24-47SP Epiphany Cathedral Parking Staff Report

Address:	225 N. Harbor Drive
Requests:	Redevelopment of an existing shell parking lot to a new paved parking lot for Epiphany Cathedral
Owner:	Frank J. Dewane, Bishop of Diocese of Venice
Agent:	Kreg E. Maheu, DMK Associates, Inc.
Parcel IDs:	0175-16-0018
Parcel Size:	±0.85 acres
Future Land Use:	Institutional Professional
Zoning:	Office, Professional and Institutional (OPI)
Comprehensive Plan Neighborhood:	Island Neighborhood
Application Date:	September 20, 2025

Site and Development Plan

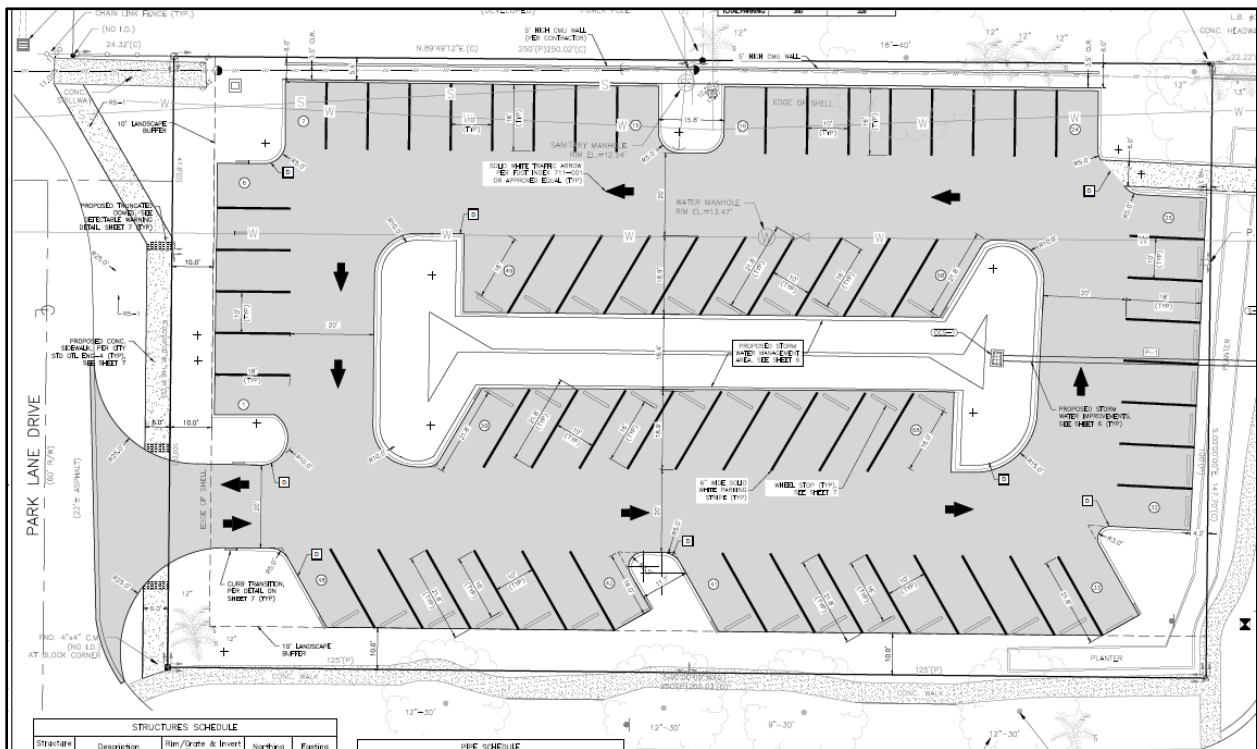
Staff Comment: *Building height and setbacks are not applicable to this project. The project is consistent with the landscaping requirements, which provide buffering to the neighboring properties.*

Summary Staff Comment: *This is an improvement project, and the use is already existing.*

Staff Comment: *The proposed site and development plan proposes to improve the existing shell parking lot to a paved parking lot with sidewalk and landscaping. The project meets all the*

requirements of remote parking in Sec. 87-3.6 of the Code. The project was reviewed by TRC and found to be consistent with the Comprehensive Plan and the Land Development Code.
